G.3 Approve Change Order Summary Report – July 2025

CHANGE ORDER SUMMARY #57

RE Chippewa Valley Schools
Bid Pack 7 – Clinton Valley Elementary Northwest Parking Lot –
Furnish and install geogrid subgrade.

DATE July 9, 2025
TO Scott Sederlund, Chippewa Valley Schools
FROM Cris Tollis, Barton Malow Builders
RE Chippewa Valley Schools
Bid Pack 7 - Dakota High School North Parking Lot

Clinton Valley Elementary
Northwest parking lot - existing paving cross section

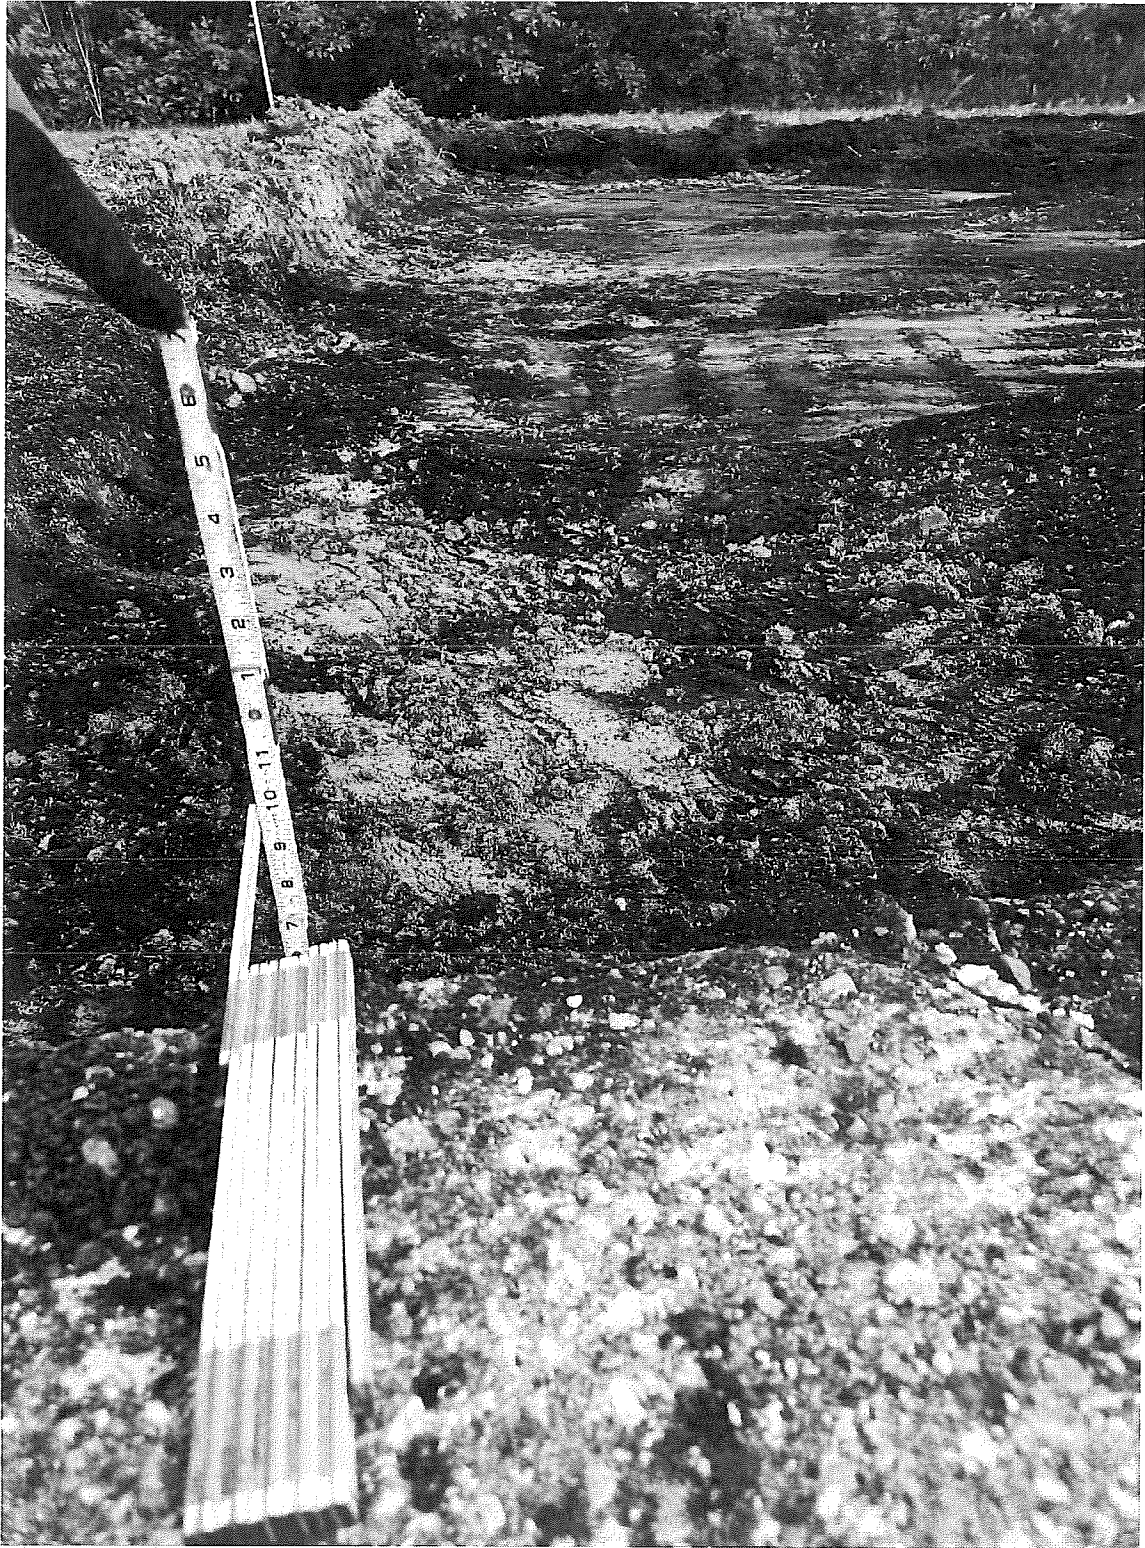
A G2 Inspector was on site during testing and noticed unsuitable soils. In lieu of undercutting, which would be more costly based solely on the volume of stone removed and stone replaced, T&M provided a geogrid subgrade. Additional stone was also required to bring the base of the new lot to the existing heights. The asphalt removed was thicker than expected (see attached photo), thus the need for additional stone backfill. This additional work will be funded from the bond program contingency budget.

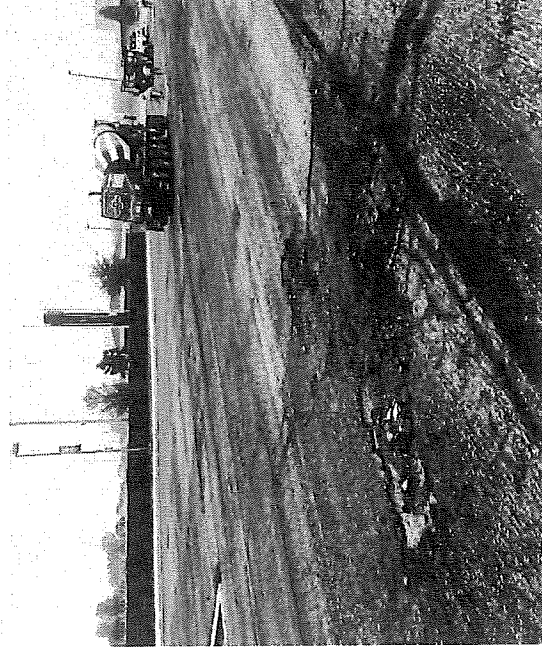
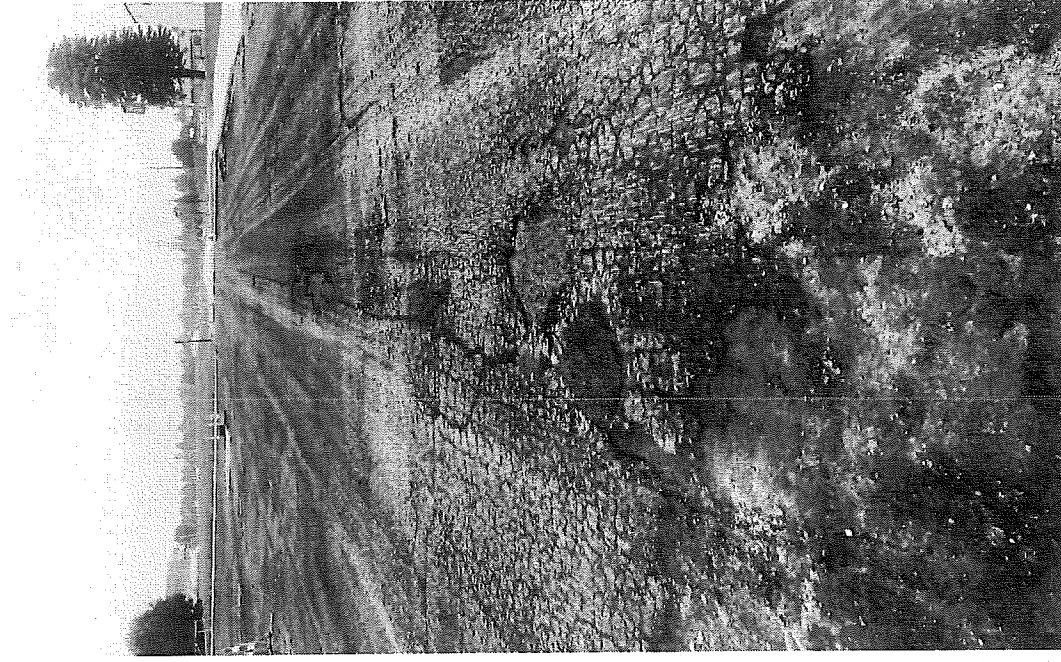
The images show areas where the milling operation has exposed a severely compromised base course, marked by cracking, voids, and material loss. These conditions confirm that the underlying structure lacks adequate support and will require significant repair or replacement to meet performance standards.

Based on this evaluation, the project team selected the full replacement option with targeted subgrade undercuts. This approach was determined to provide the most durable long-term solution while balancing cost and performance expectations.
